◀ IMPORTANT UPDATE ▶

The attached Technical Instructions has been updated. Refer to the details below.

DATE	TOPIC
4/3/2026	Added new Calibration IDs chart if OTA is completed
1/20/2026	RX models – Combination meter replacement only – Software update is not required added to calibration chart
1/15/2026	Phase 2 Launch

TECHNICAL INSTRUCTIONS
FOR
25LA05
REPROGRAMMING FOR COMBINATION METER ASSEMBLY

1. CONFIRM THE CALIBRATION ID FOR THE COMBINATION METER SYSTEM

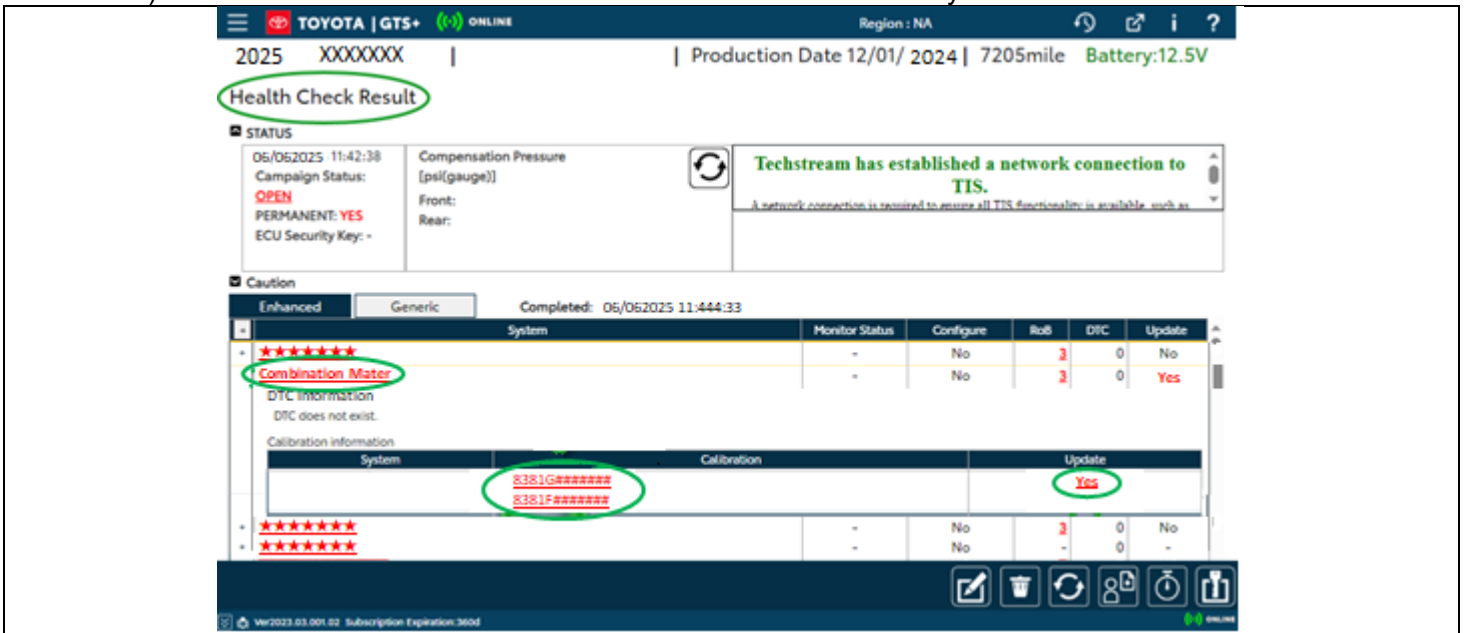
IMPORTANT OTA INFORMATION

If OTA (Over the Air update) has been performed by the customer the CID will be different than the GTS+ new CID. Please reference the chart below for the affected models.

Vehicle Model	Current		New			
			GTS+		OTA	
	CID	Version	CID	Version	CID	Version
Lexus LS	8381F5007200	1002	8381F5007400	1004	8381F5007500	1005
	8381F5007300	1003				
Lexus TX	8381F0E01100	1004	8381F0E01300	1009	8381F0E01500	1011
